# Recall Campaign

June 2019  
FL761A-C  
NHTSA #18V-157 (School Buses)  
#18V-158 (Non-School Buses)  
Transport Canada #18-119 (School Buses)  
#18-120 (Non-School Buses)

## Subject: TBB Minotour Wheelchair Lift Interlock

**REVISIONS:** A procedure for FL761-C has been added and the work instructions and parts table have been updated.

**Figure 2: Current Harness Installation**

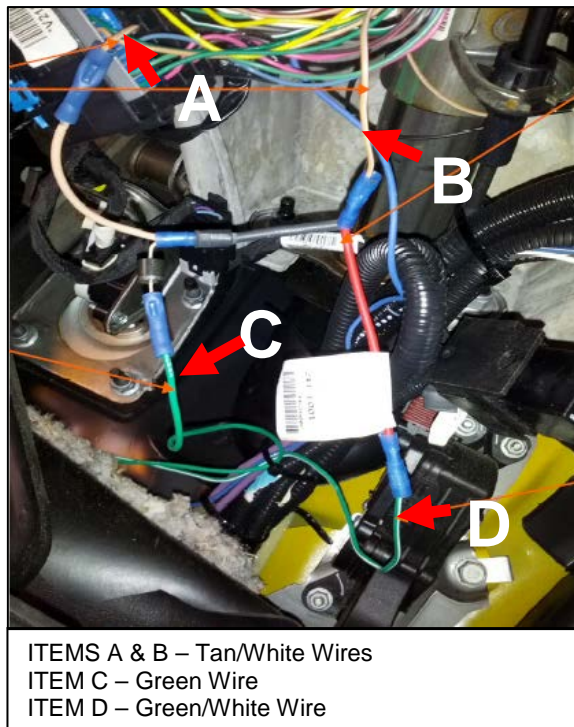
3. Cut the two brown wires between the connectors shown in **Figure 2 Items A and B** as close to the butt splice as possible (to allow connection to the new harness).

4. Install new harness TBB 175974 as shown in **Figures 2 and 3**.
  - 4.1 Connect the new harness to Positions A and B, where the brown wires were cut.
  - 4.2 Connect the existing green wire to Position C on the new harness.
  - 4.3 Connect the existing green/white wire to Position D on the new harness.

Figure 5: Connections at Relay

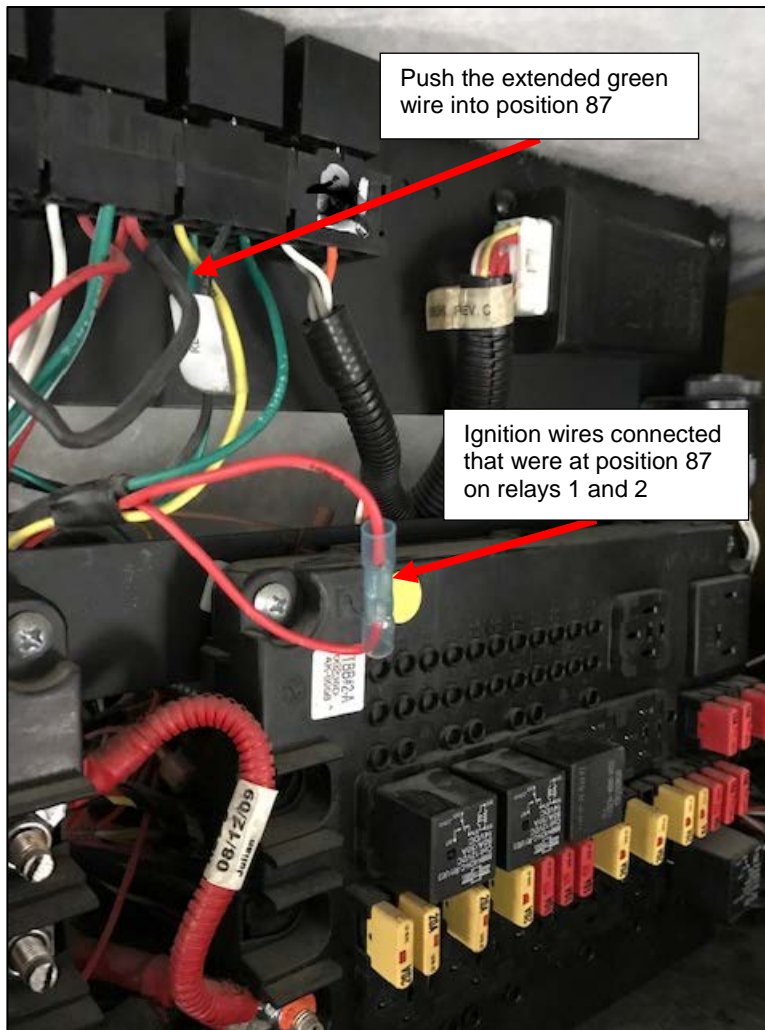
3. On relay 1 on the lift harness (on the metal mounting plate of the PC board), remove the ignition wire from position 5, which is 87 on the relay. See **Figure 5** for position and conversion of the relay block.
4. Put a spade terminal on the green wire that was added and plug it into position 5.

Figure 6: Schematic of Harness and Relays

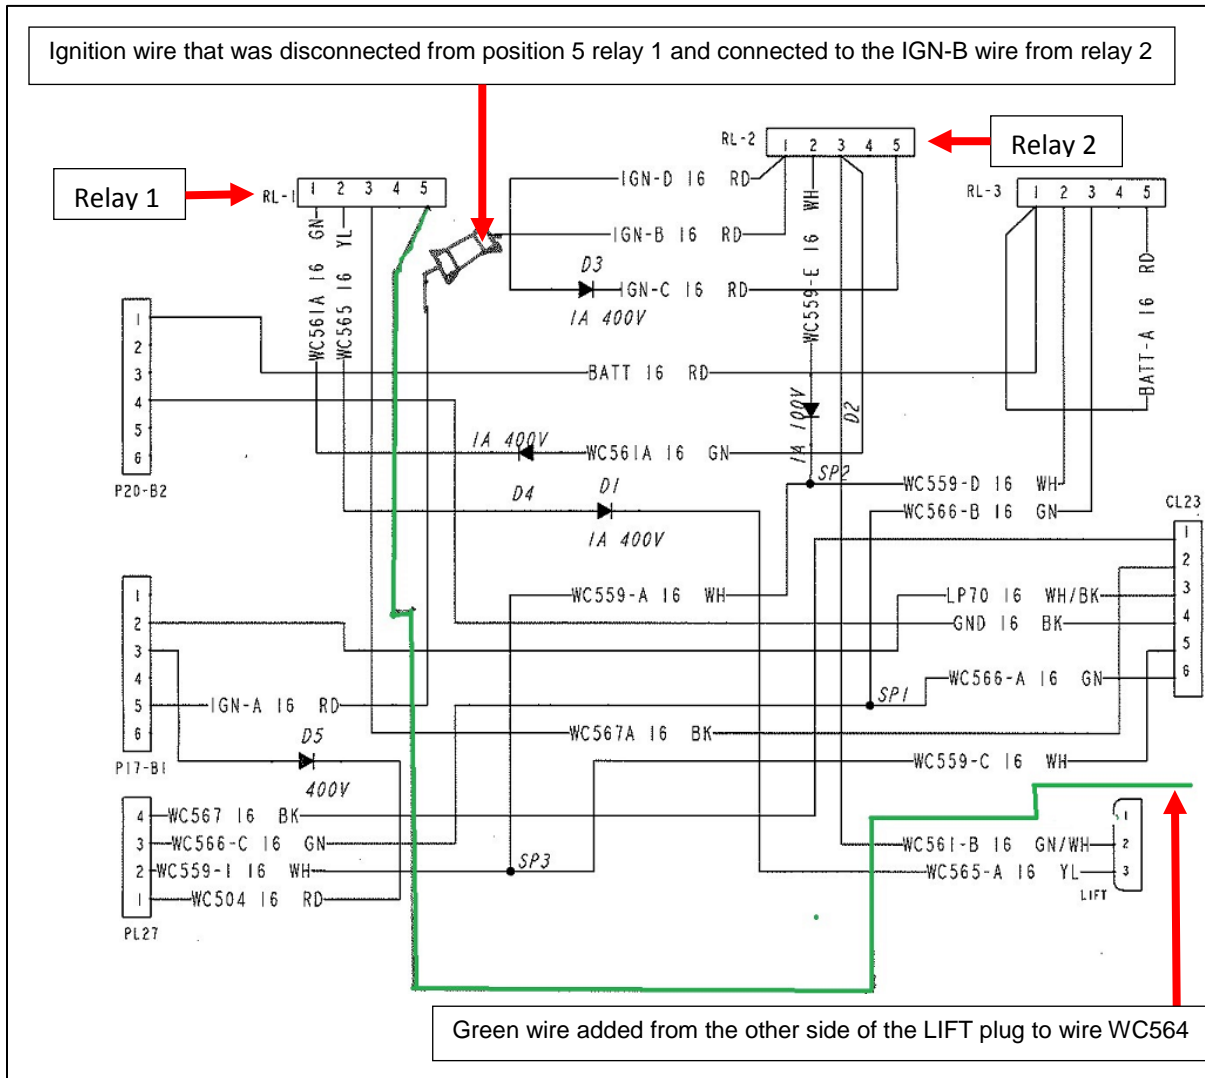
5. Connect the ignition wire that was in position 5 to the wire that was also in the same position 5 on the relay with a butt connector. See **Figure 6** and **Figure 7** for a schematics/diagrams showing the connections.

Figure 8: View of PC Boards

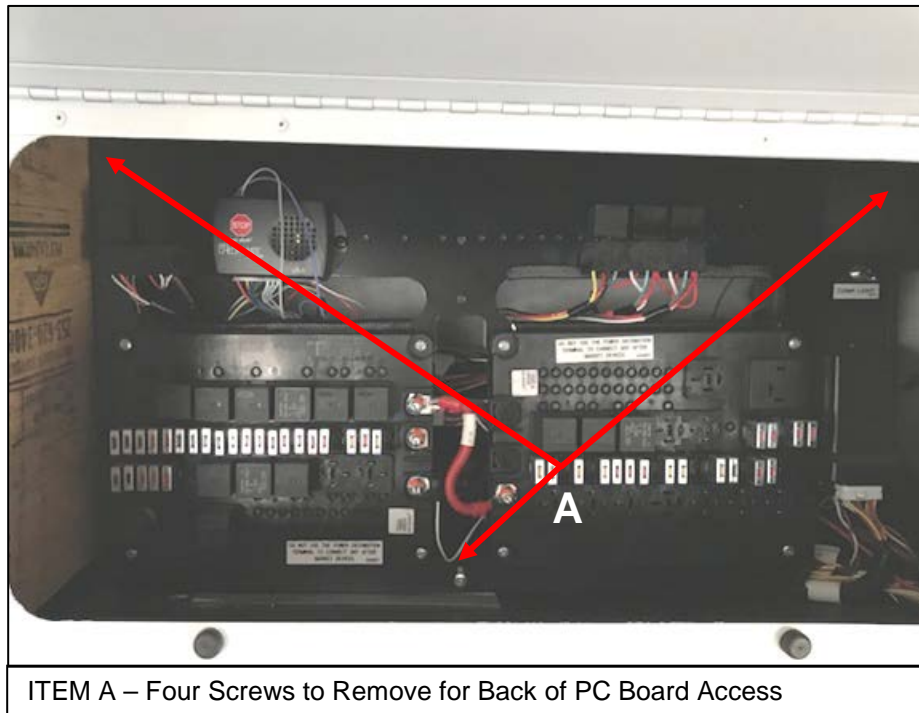
4. Open the PC circuit board cabinet (above the driver's seat) and prop the door open. See **Figure 8**.
5. Remove the three screws indicated in **Figure 8** and lay the PC board down.

Figure 11: Rear of PC Boards Showing Connections, Only

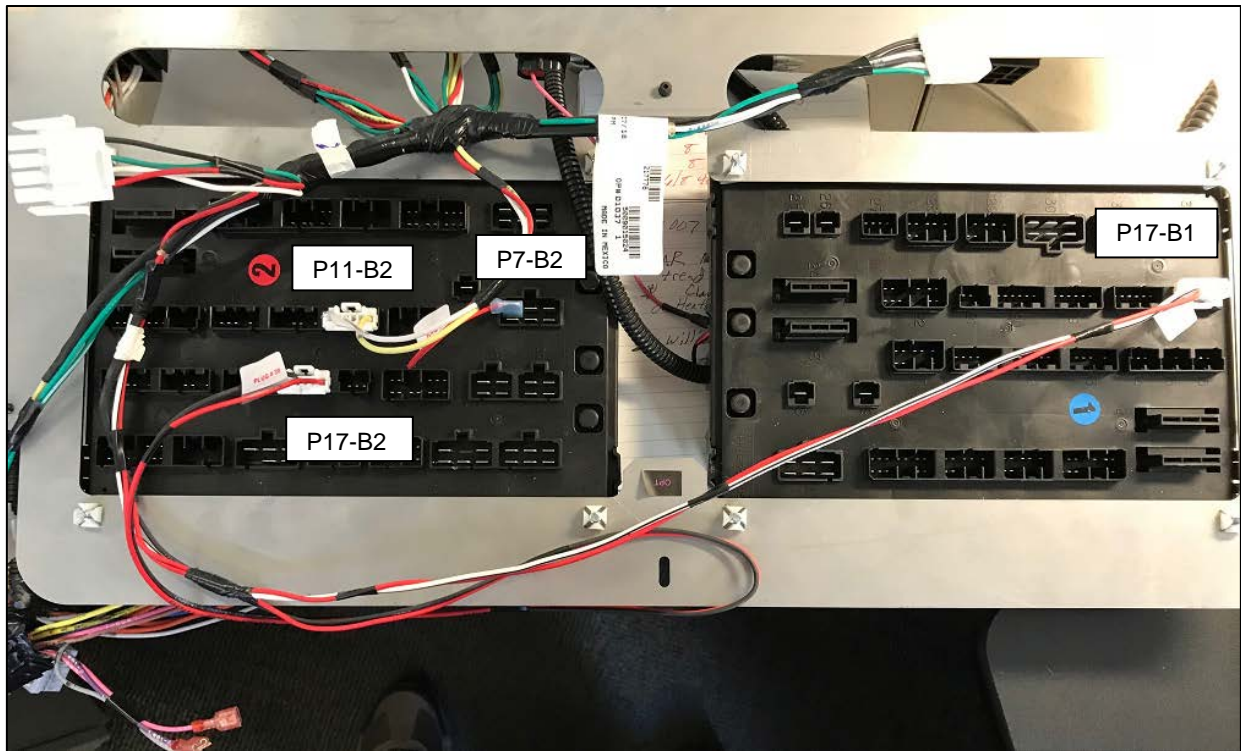
6. Remove the side cushion, retain it and screws. See **Figures 9 and 10**.
7. Remove the existing harness and install the new harness TBB 217778. The old and new harnesses have the same connection points on the back of the boards and connecting harnesses. **Figure 11** shows the locations on the back of the PC board. The remaining plugs on the harness will be connected to harnesses that are not plugged into the PC boards.

8. Remove each plug on existing harness TBB 150043 from the PC Boards one at a time and replace with the corresponding plug from the new harness TBB 217778. Once the PC board plugs are swapped, do the same with the remaining connections to harnesses as labeled.
